TOWN OF WEST WARWICK
REQUEST FOR PROPOSALS (RFP)

GENERAL CONTRACTOR
30 Payan Street Renovation

ADDENDUM #2
Posted 2/12/2026

RFQ/P REFERENCE NUMBER: 2026-08
RFP RELEASE DATE: January 27, 2026

1 FIRST FLOOR DEMOLITION CEILING PLAN
FPD2.01 SCALE: 1/8" = 1'-0"

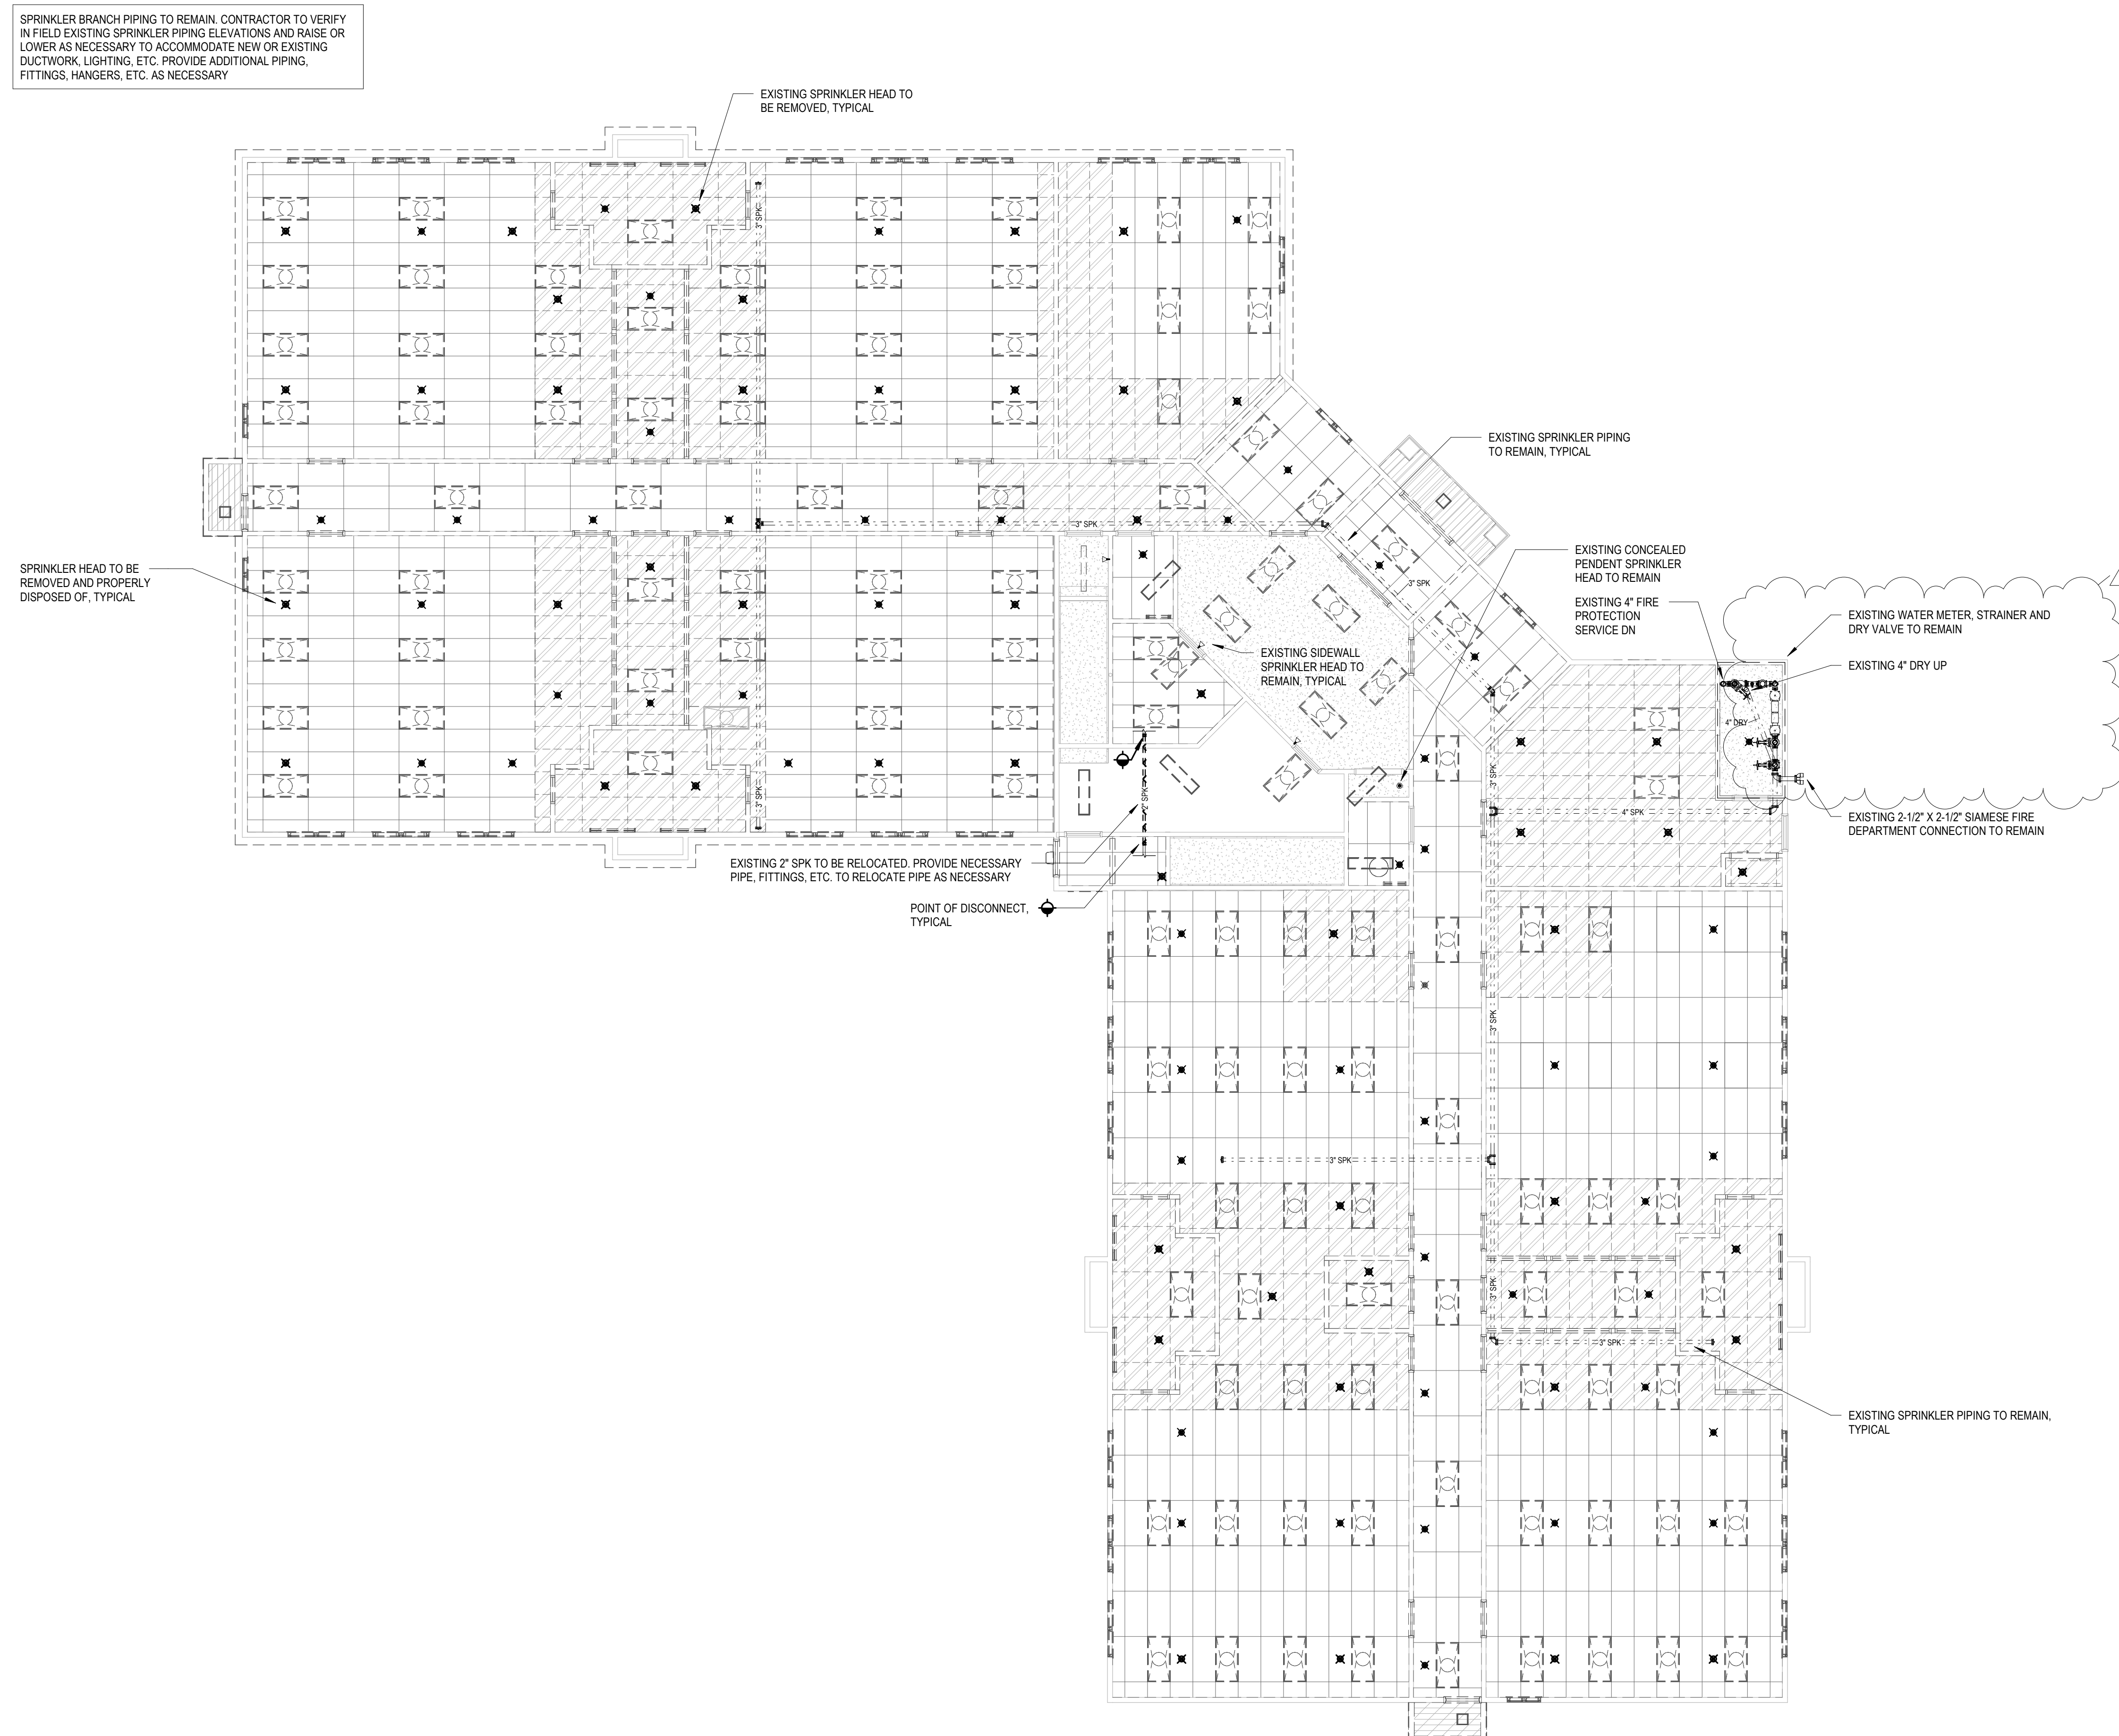
11. FPD2.01 FIRST FLOOR DEMOLITION – FIRE PROTECTION
 - Removed demolition of existing backflow preventer.
12. FP2.01 FIRST FLOOR CEILING PLAN – FIRE PROTECTION
 - Removed installation of new backflow preventer.
13. FP5.01 SCHEDULES – FIRE PROTECTION
 - Removed backflow preventer schedule.
14. FP6.01 DETAILS – FIRE PROTECTION
 - Removed horizontal double-check detector backflow preventer detail.
15. P5.01 SCHEDULES - PLUMBING
 - Added mixing valve model to L1 in Plumbing Fixture & Equipment Schedule.
16. M1.01 FIRST FLOOR PLAN - MECHANICAL
 - Indicated return grille airflows.
17. E0.01 COVER SHEET – ELECTRICAL
 - Added pressure switch to symbol list.
18. E1.01 FIRST FLOOR PLAN – ELECTRICAL
 - Revised storage room 120.1 to provide new tamper, flow, and pressure switches for the existing to remain backflow preventer.
